Point-to-point replies to the review report

Thank you for your submission to ESSD. I am happy to begin the open discussion and review phase.

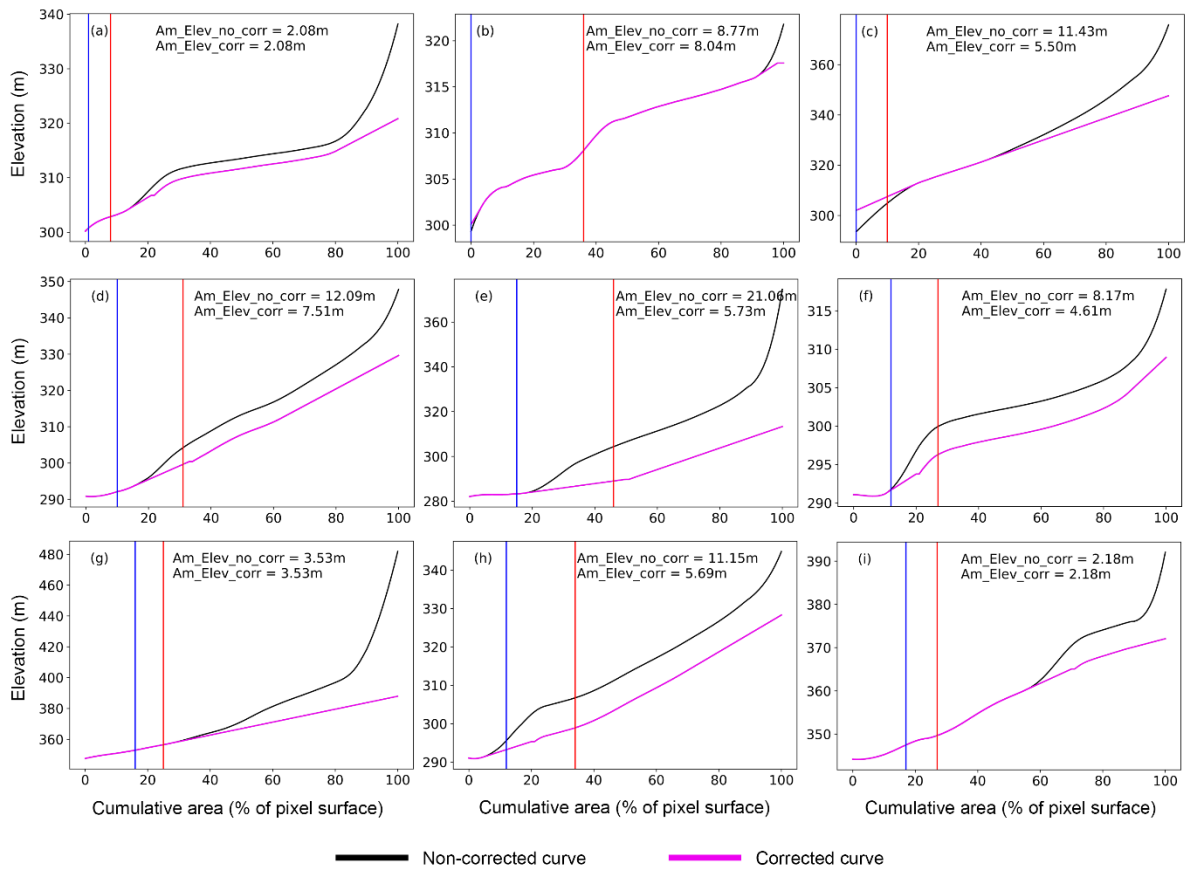
- 4. Figure 4, black line and grey line are not easy to distinguish. Maybe use another color to update one of them.**

9. For Figure 4 and Figure 5, what does the subfigure number (a-i) mean? Please clarify in the figure captions.

Our Reply: Following your comment, we have changed the color of the lines and the figure caption. Figure 4 and its caption are now as follow:

Our Reply: Thank you for your comment. We have added in the figure captions 4 and 5 a sentence to clarify the meaning of the subfigure number (a-i). Figure captions 4 and 5 are now as follow:

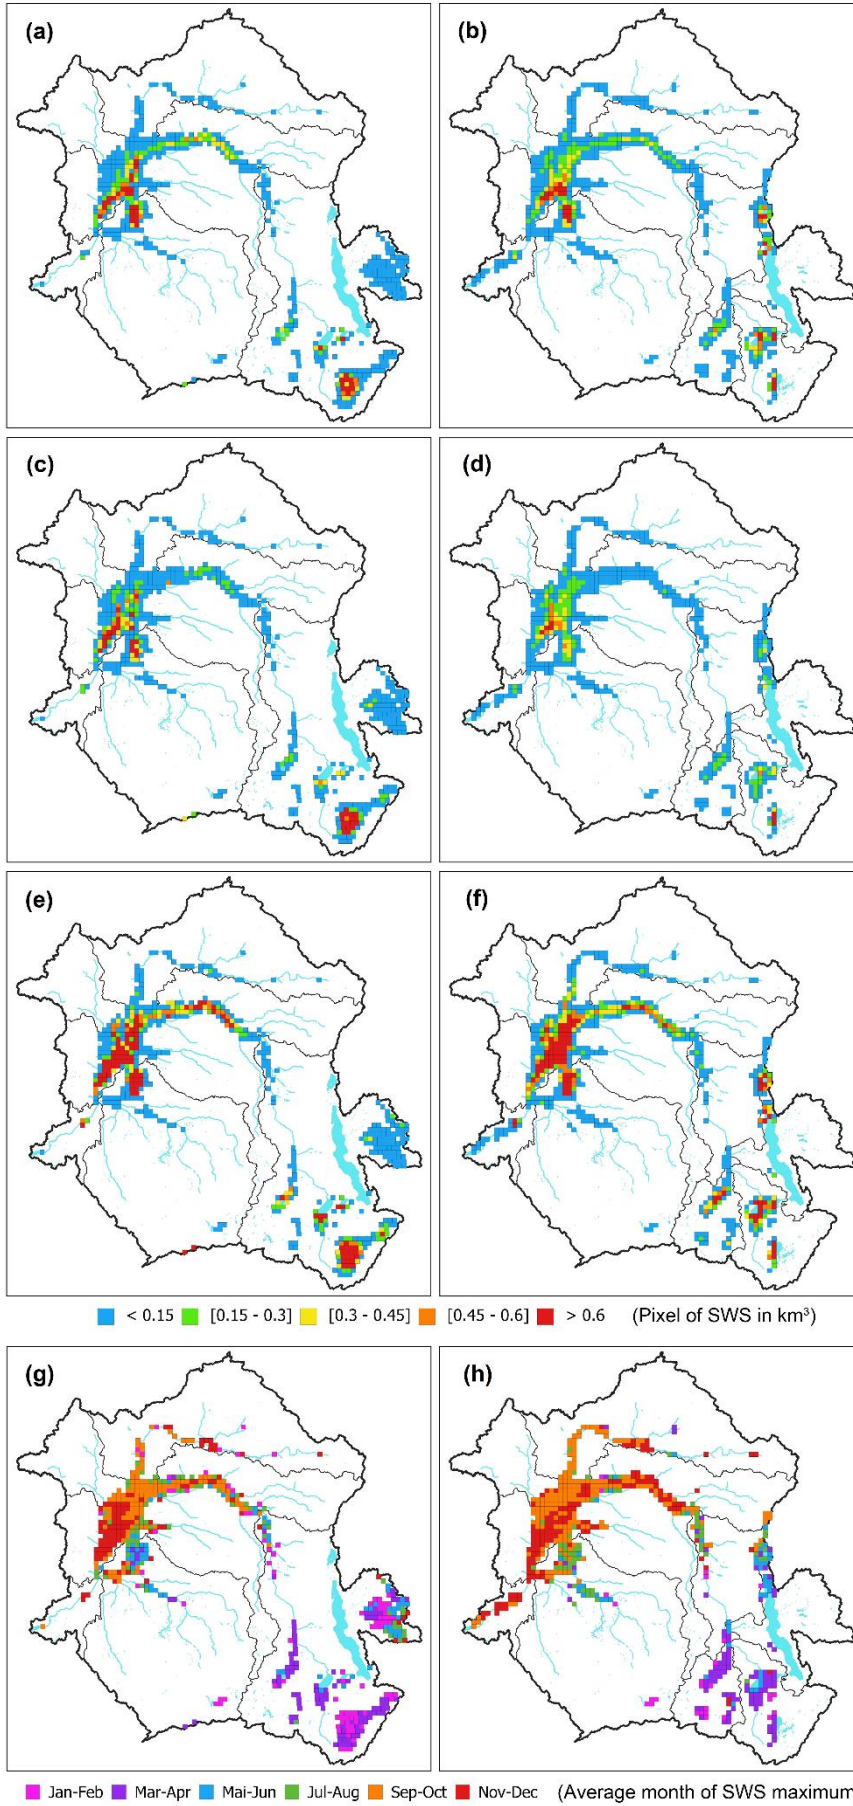
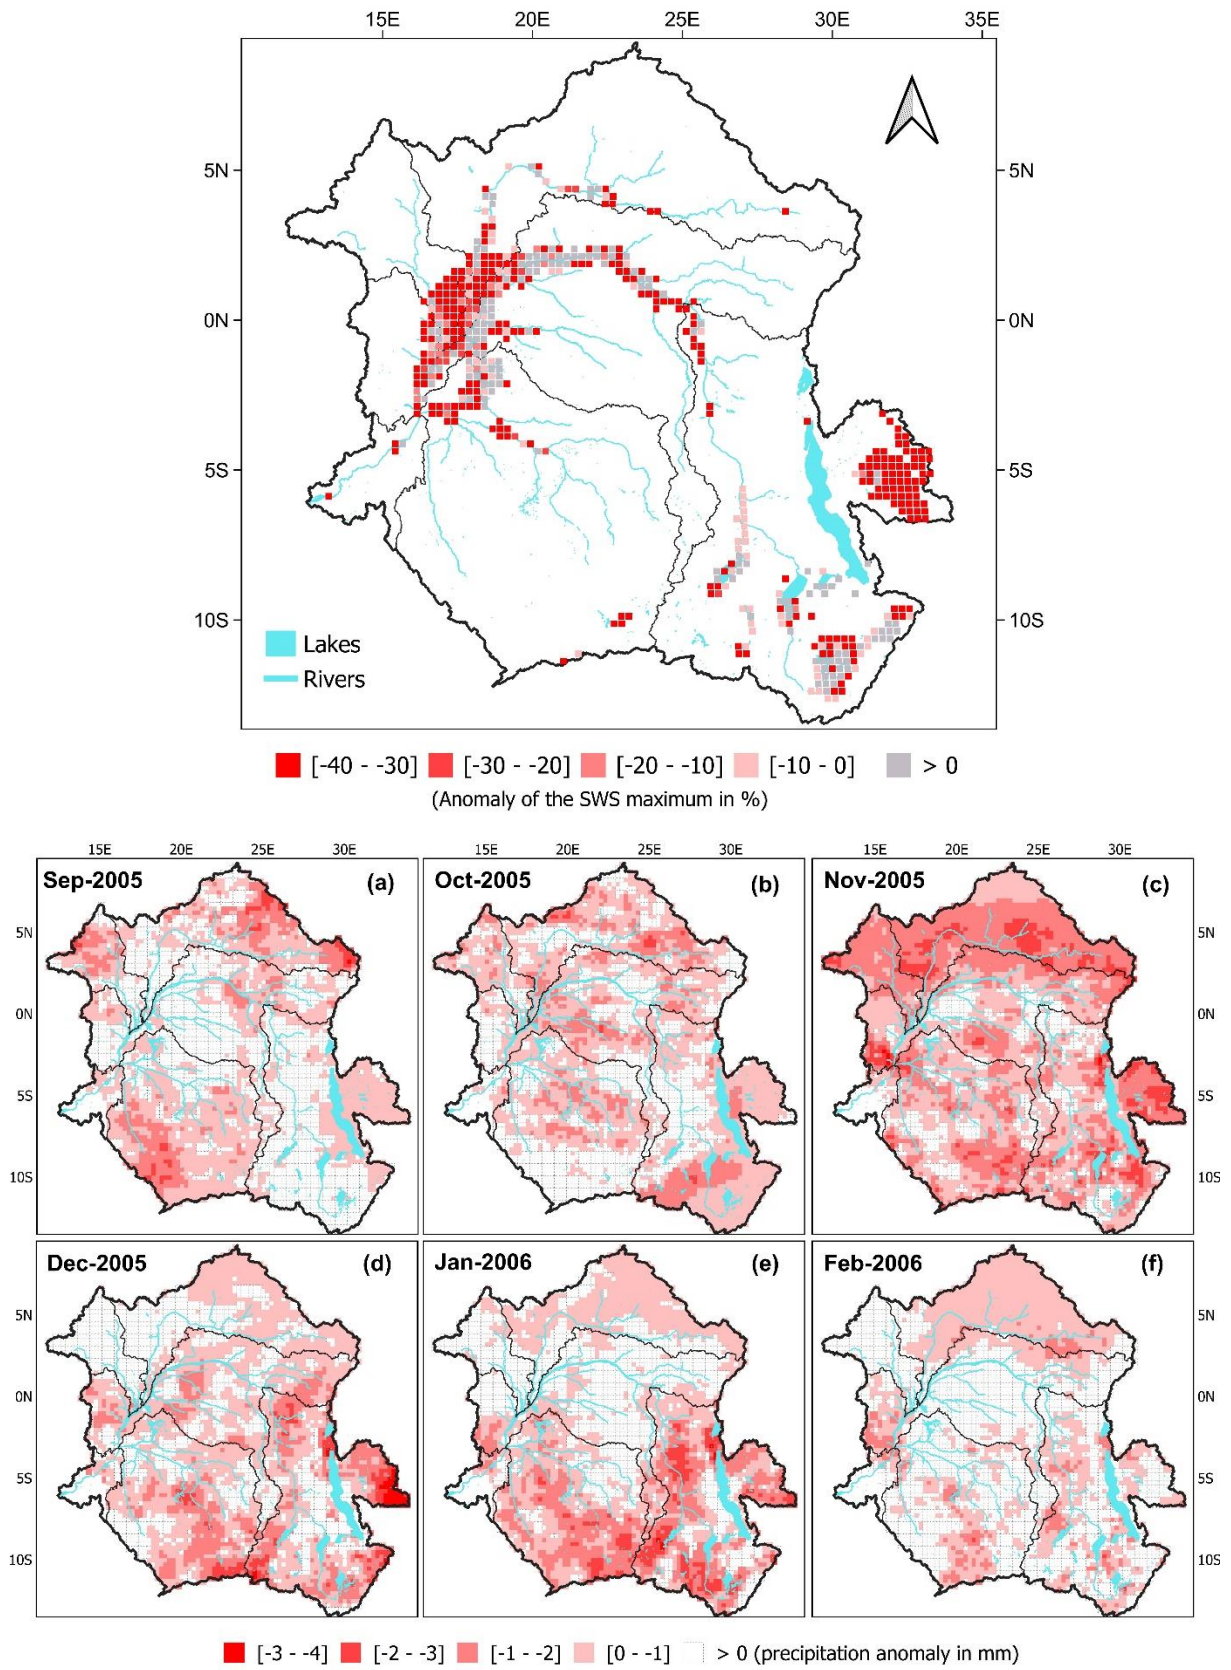
7. Figure 7, 10 and 11, the legend should be more standardized. The legend should have a name so that the readers can understand the maps clearly and directly.

Our Reply: Following your comment, we have standardized the legend. Figure 7, figure 10 (now figure 11 due the insertion of the new figure 9 on TWSA comparison with SWS), and figure 11 (now figure 12) are now as follow:

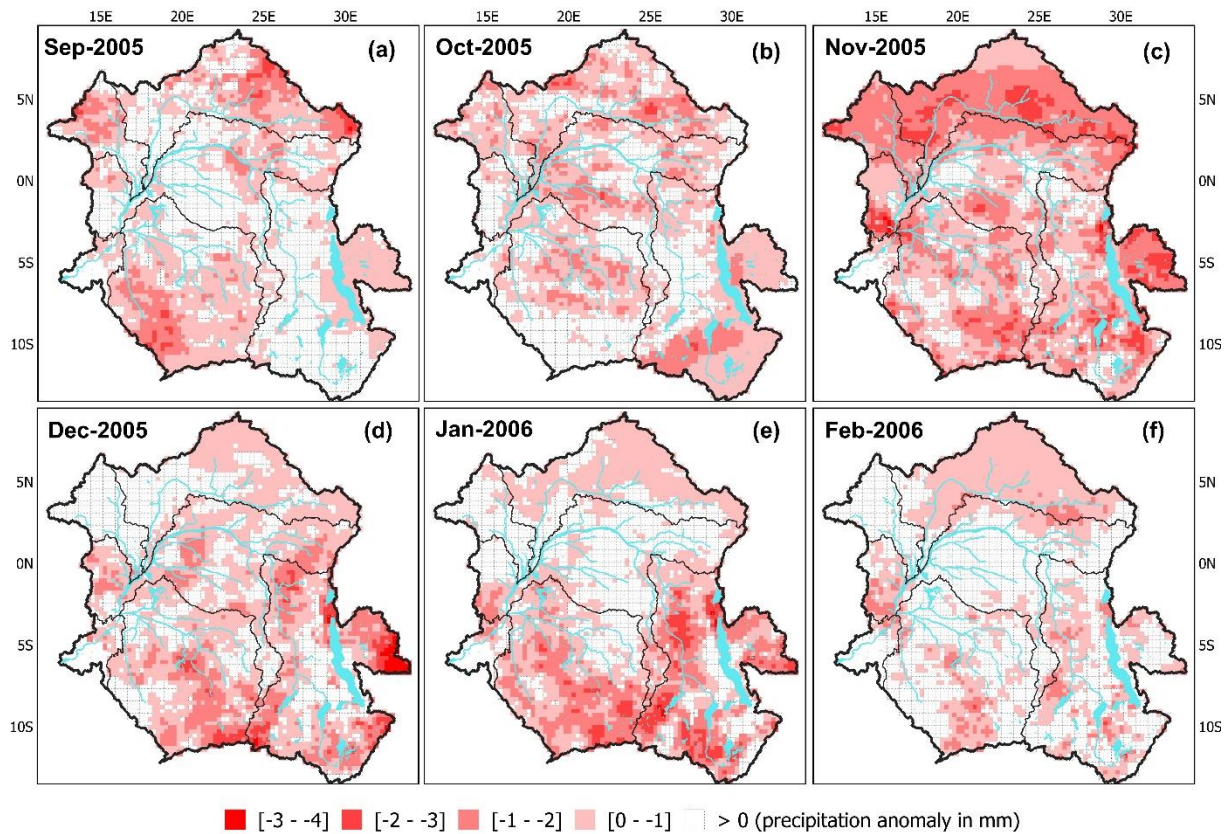
8. Figure 11f, Feb-2006.

Our Reply: Following your comment, we have changed in figure 11f "Fev-2006" in "Feb-2006". Figure 11 (now figure 12) is now as follow:

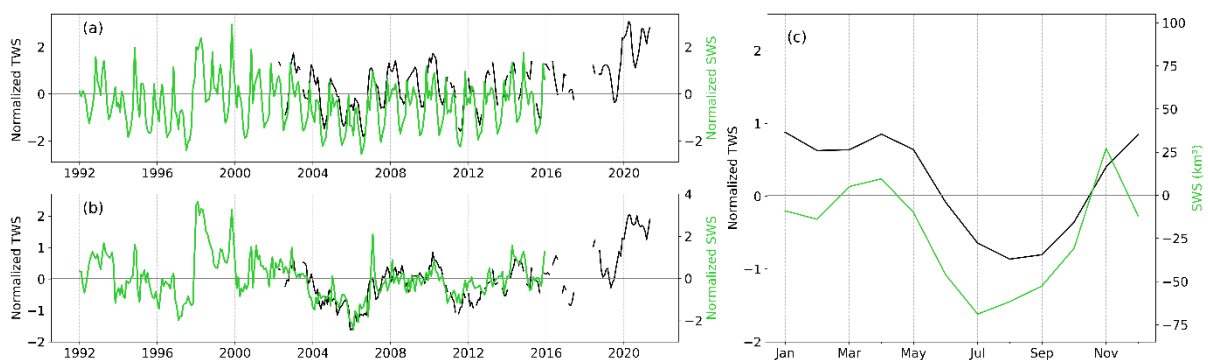
10. It is good to see that there is evaluation against independent datasets in Section 5.2. However, I think a time series comparison or correlation analysis with the precipitation and discharge is not convincing enough to showcase the reliability of this dataset, especially in the perspective of spatial information. Is it possible to compare the SWS with the GRACE products? Or maybe validate some of the SWE results with Landsat observations at least?

Following your advice, we have decided to perform the comparison of our SWS dataset with GRACE data. Firstly, we have added a new part in section 3.6 that describes the GRACE data we use. The comparison is shown in a new Figure 9 and discussion are presented in section 5.2. All the new material related to GRACE data are as follow:

In the section 5.2 on **Evaluation against independent datasets**, we have added the following comments: "Figure 9 displays the comparison at the basin level between the aggregated normalized SWS anomaly and TWSA from GRACE. Both variables, show a similar interannual variability during the common period of availability of data (i.e., 2002 to 2015) presenting a fair correlation of $r = 0.84$ (lag = 1; p value < 0.01; Fig. 9a). It is worth to mention as well that both datasets capture the bi-modal patterns. Figure 9b presents the deseasonalized normalized anomaly for the two variables ($r = 0.4$; lag = 0; p value < 0.01), showing quite similar variations, especially in the long-term variability. We also notice the higher magnitude of the normalized SWS anomaly as compared to the normalized TWSA. At the seasonal time-scale, Fig. 9c reveals a similar behavior, with the two peaks depicted in the two variables, one in November-December and one in April. The lowest level of the SWS happens in July that is one month ahead of TWSA minimum."
